ADDENDUM NO. 1

WASHINGTON STATE PARKS AND RECREATION COMMISSION WILLAPA HILLS STATE PARK TRAIL MENLO TRAILHEAD SW-C1219

DATE: May 29, 2025

PAVEMENT
MARKING AND
MISC. DETAILS

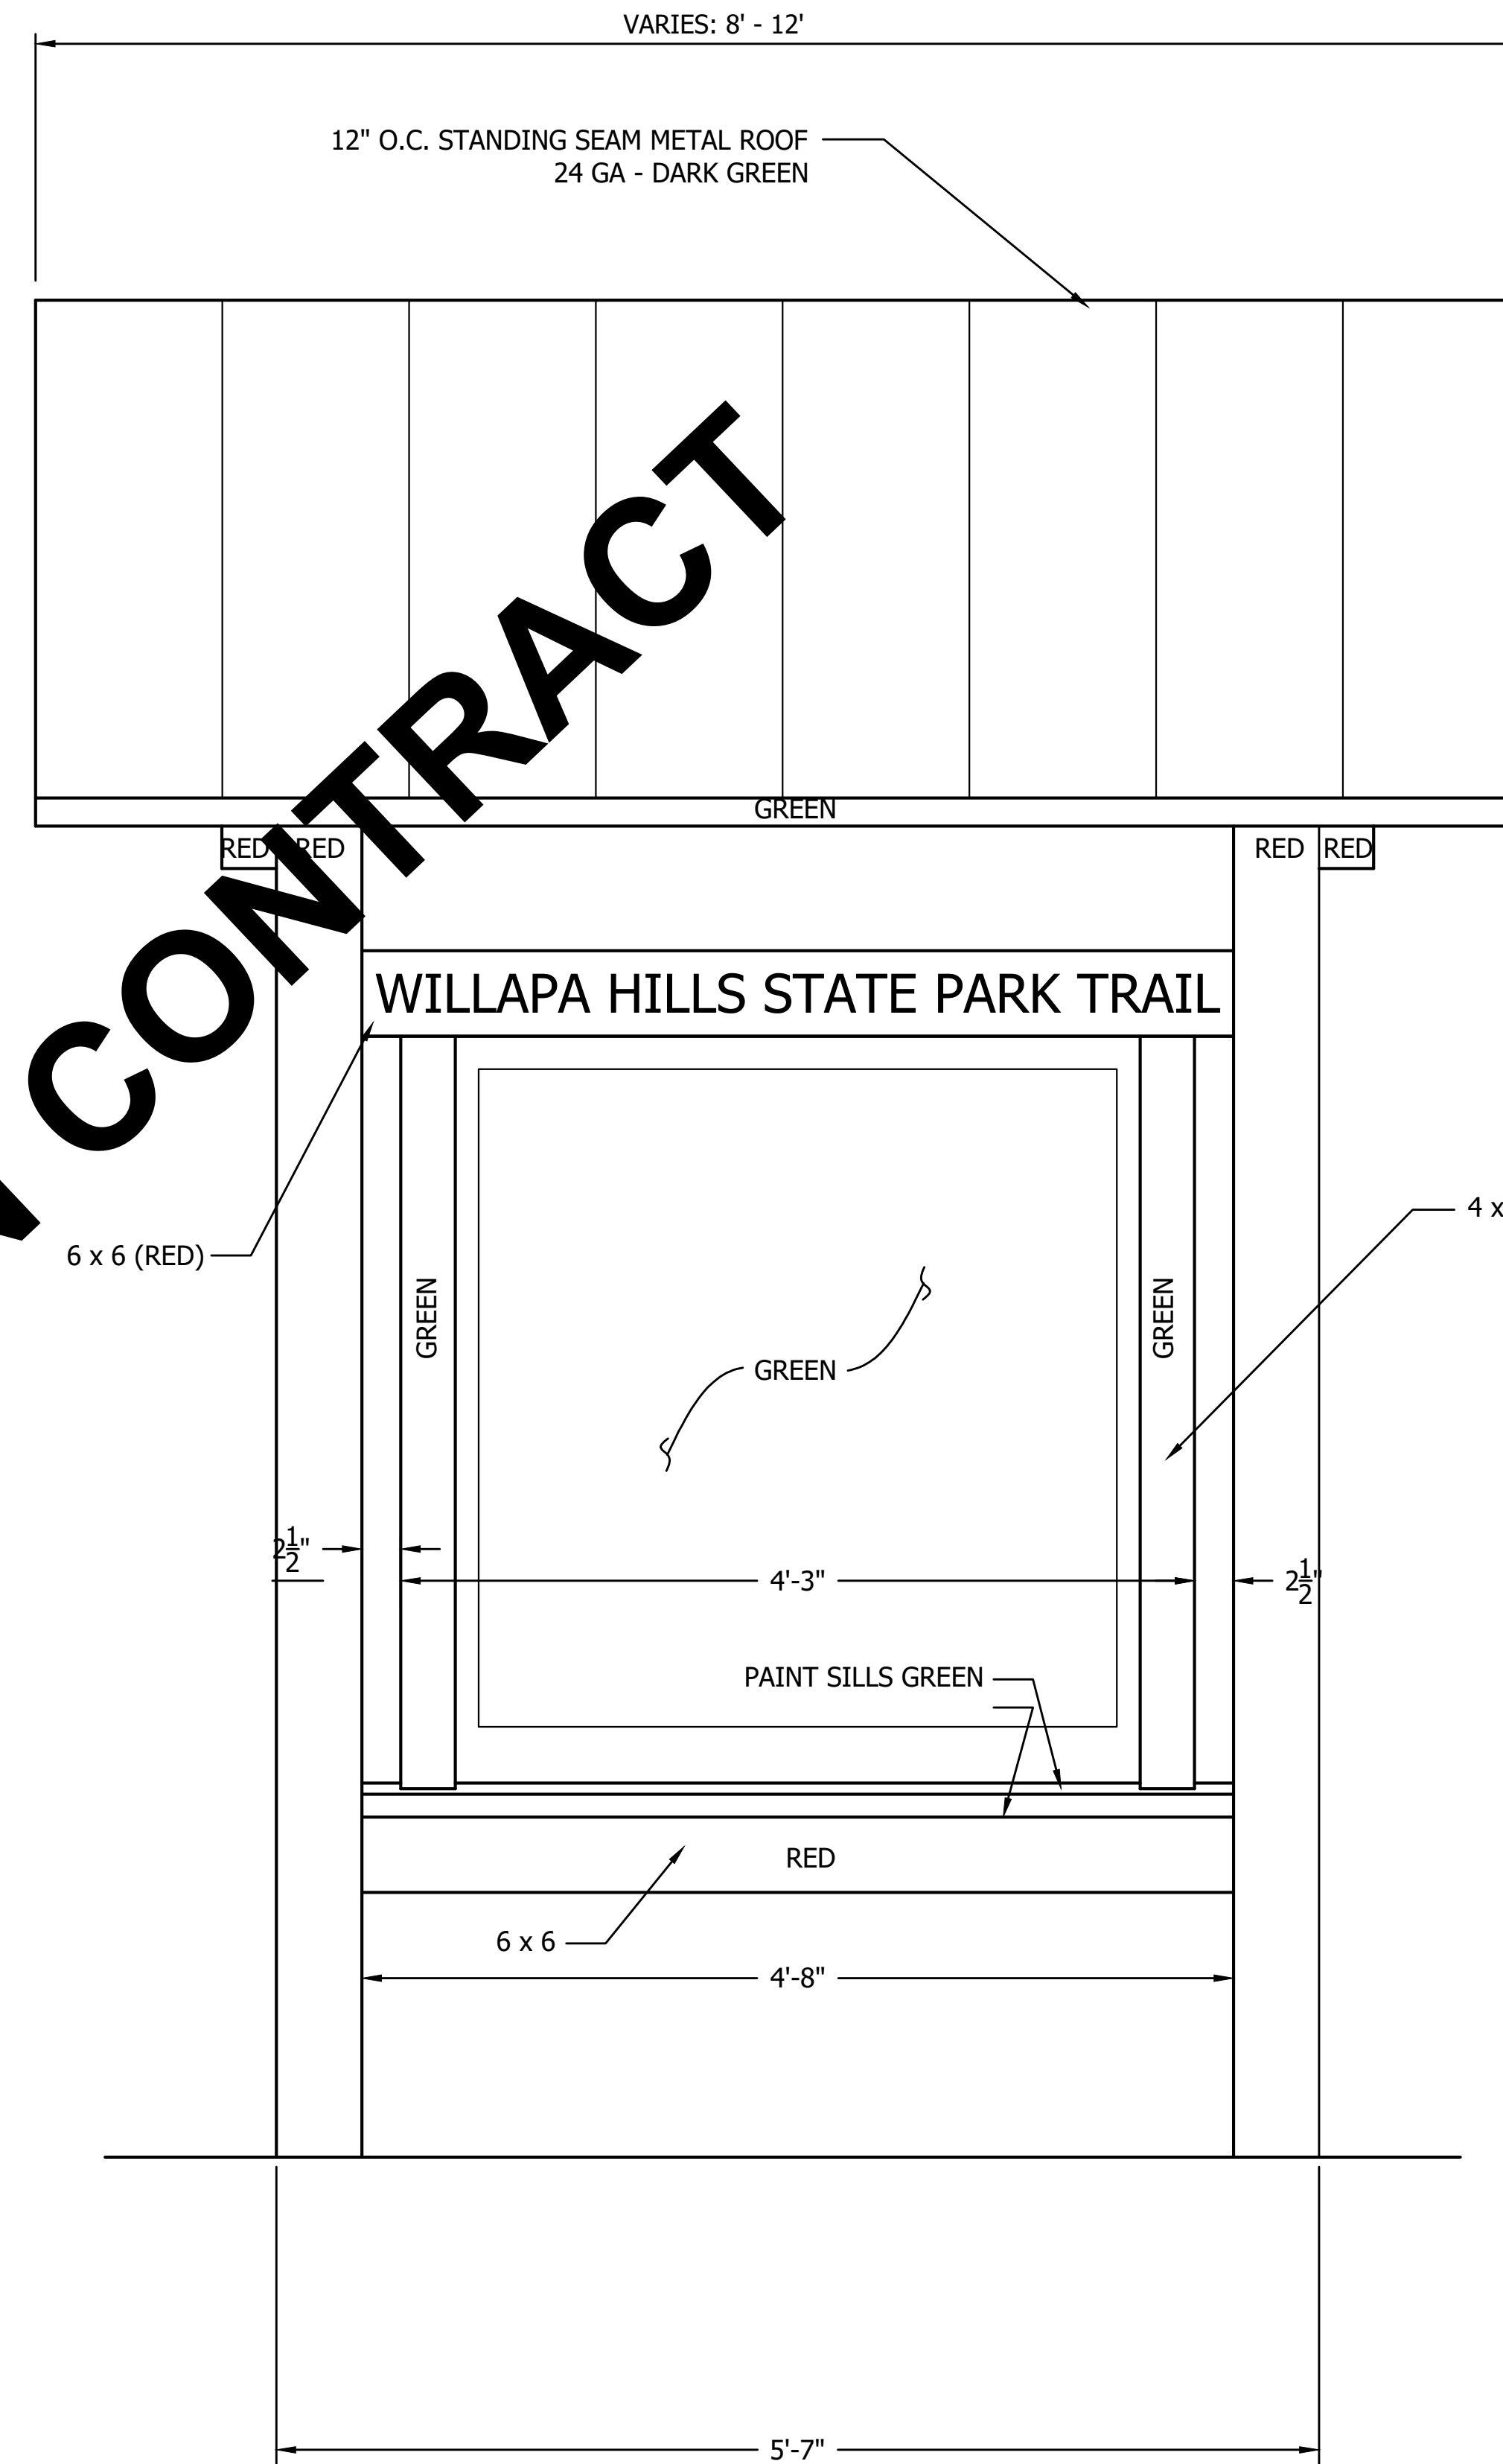
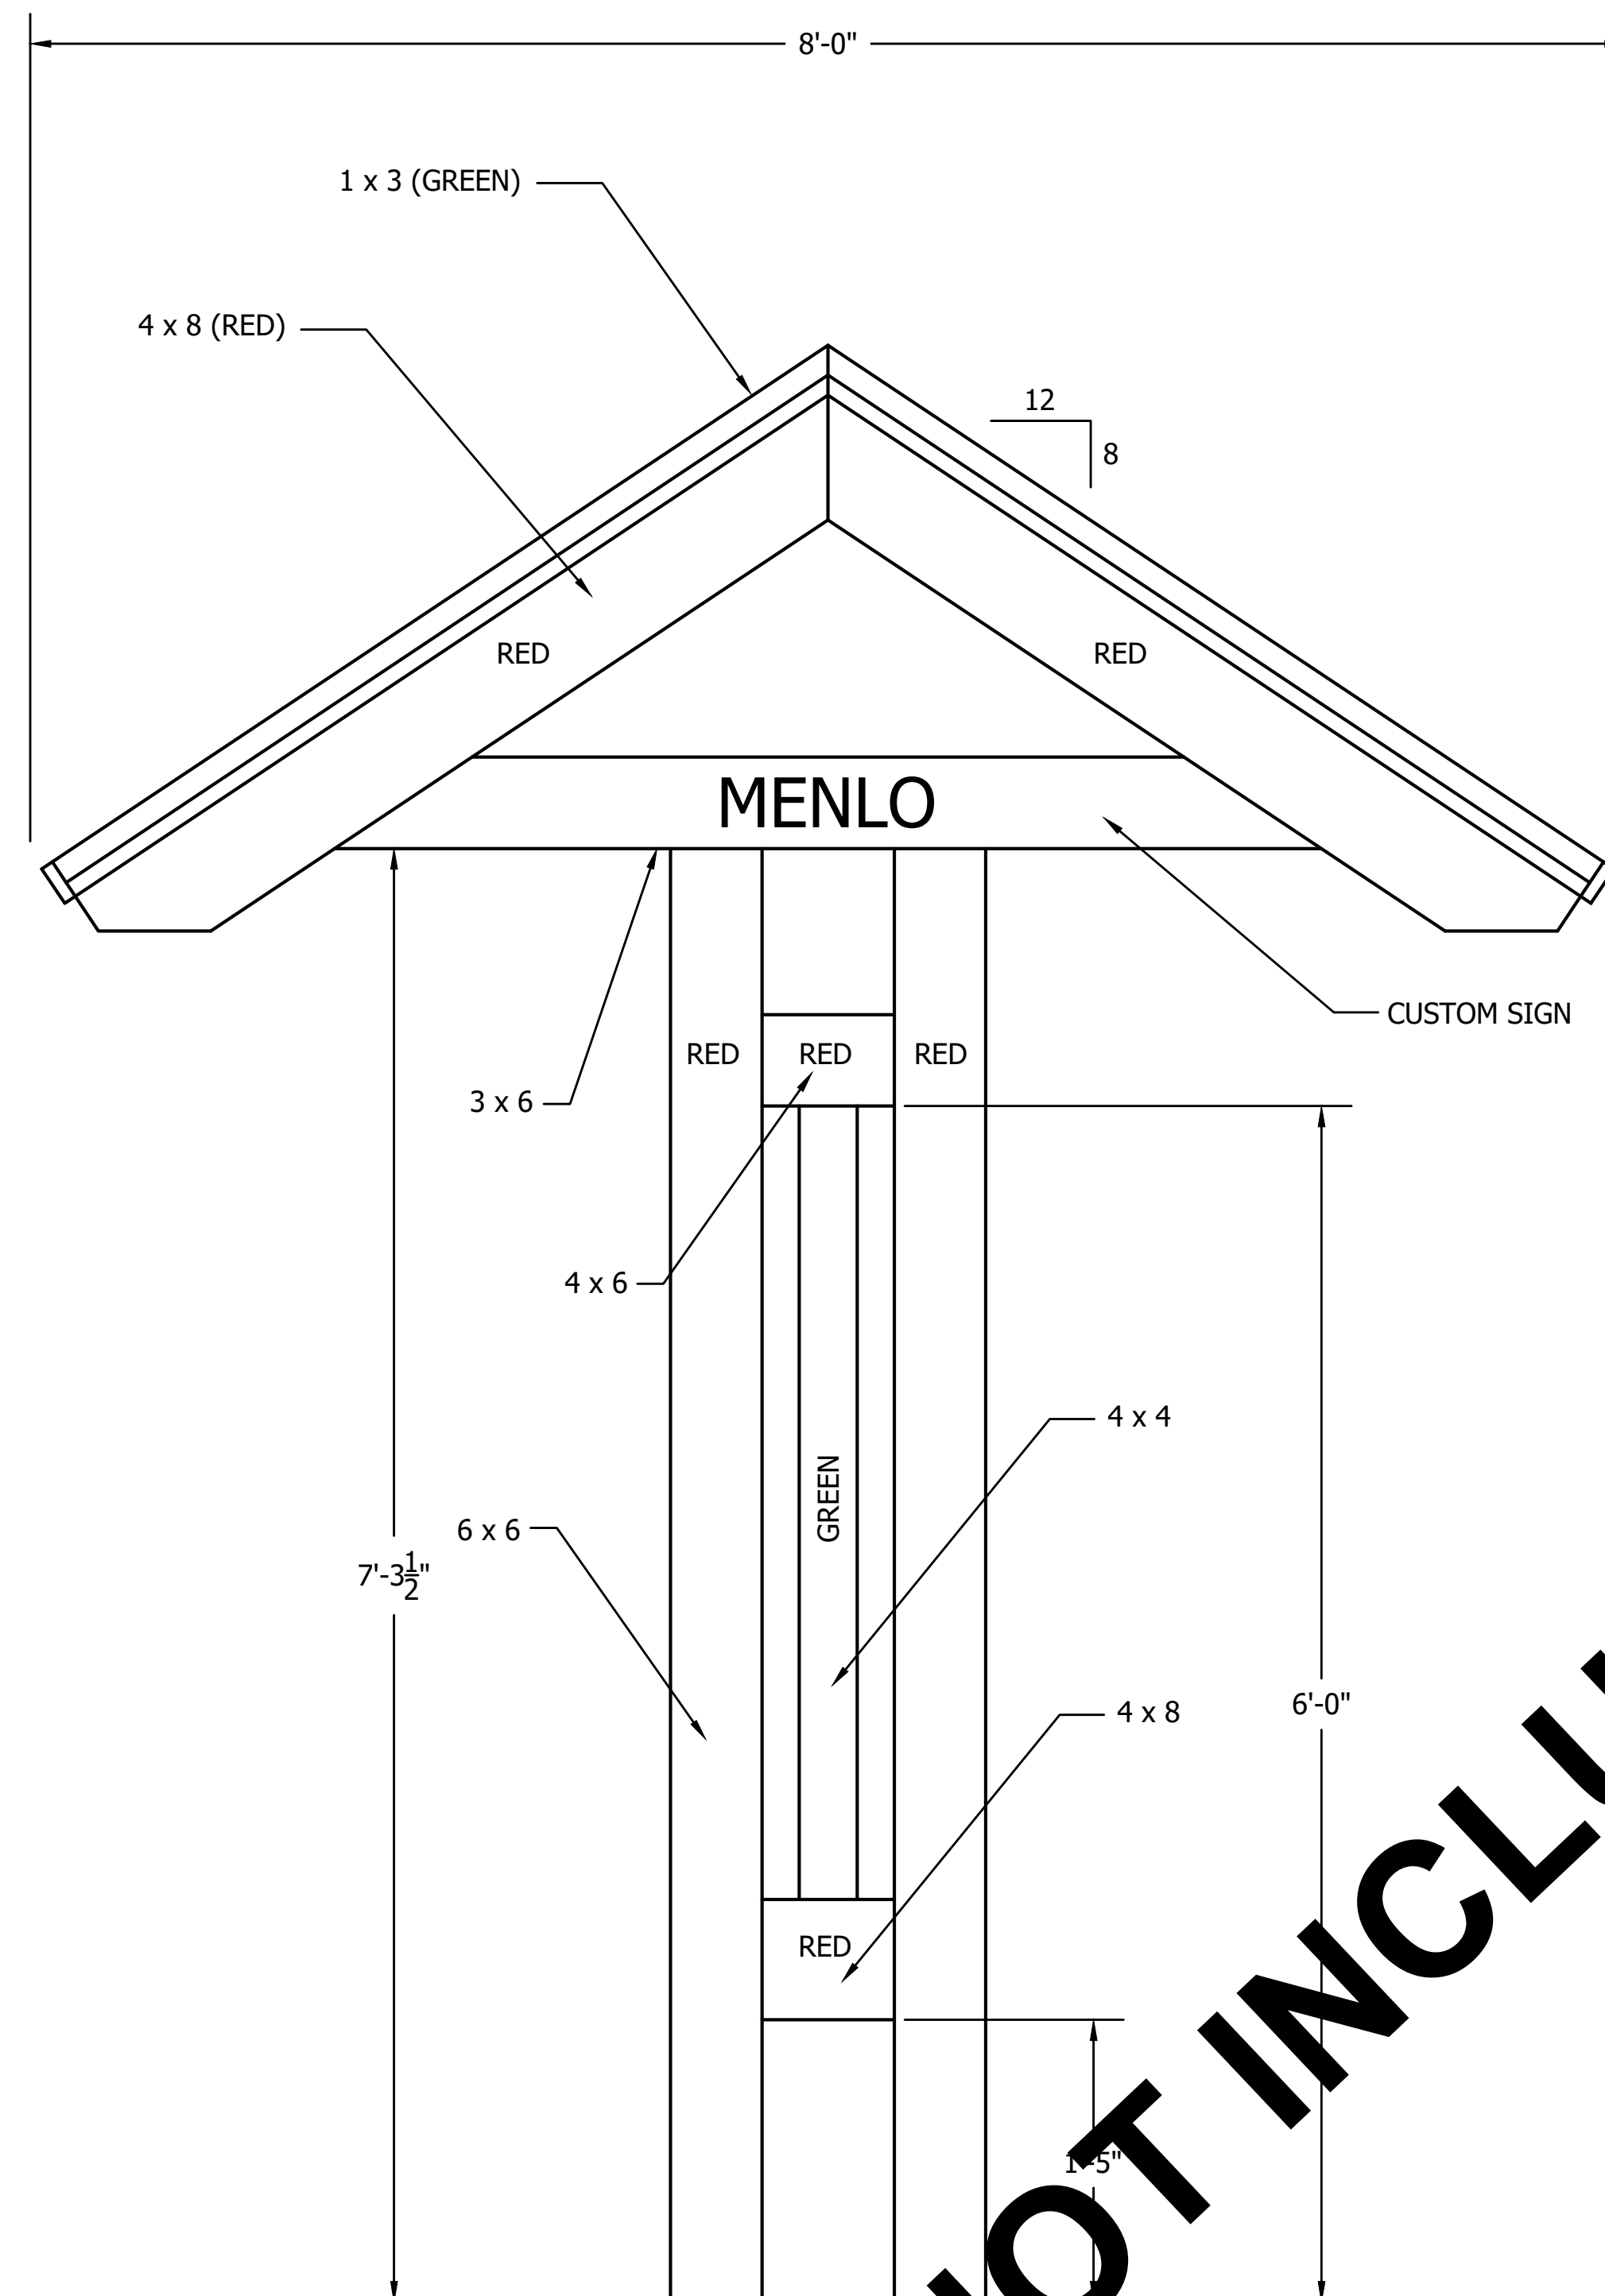
- Sheet 3** **Revise:** Call outs for Kiosk – Install Park Furnished Kiosk See Sheet 10
Call out for Retaining Wall - Provide retaining wall see sheet 4 & 7
- Sheet 7** **Revise:** Retaining Wall Notes – 3. Add or approved equal.
- Sheet 8** **Delete – Not in Contract**
- Sheet 9** **Delete – Not in Contract**
- Sheet 10** **Revise – Only Post Base Detail Included in Contract**
- Sheet 11** **Delete – Not in Contract**
- Sheet 12** **Revise:** Note call out Project Begins Limits & Project Ends Limits
Drawing Legend Notes - Bollard – Install Park Furnished bollards as directed (TYP 44)
22

- RETAINING WALLS MUST BE INSTALLED AND CONSTRUCTED ACCORDING TO THE CONTRACT DRAWINGS.
- CONTRACTOR SHALL VERIFY THE ACTUAL LENGTH OF RETAINING WALL ONSITE.
- RETAINING WALL UNITS AND INSTALLATION SHALL CONFORM TO THE ELITE KELLEY BLOCK (LEGATO BLOCK) OR APPROVED EQUAL. RETAINING WALL SYSTEMS SPECIFICATIONS GUIDELINES.
- BACKFILL NATIVE SOIL BEHIND THE RETAINING WALL
- NO GEOGRID IS REQUIRED
- NO DRAIN PIPE IS REQUIRED BEHIND THE WALL
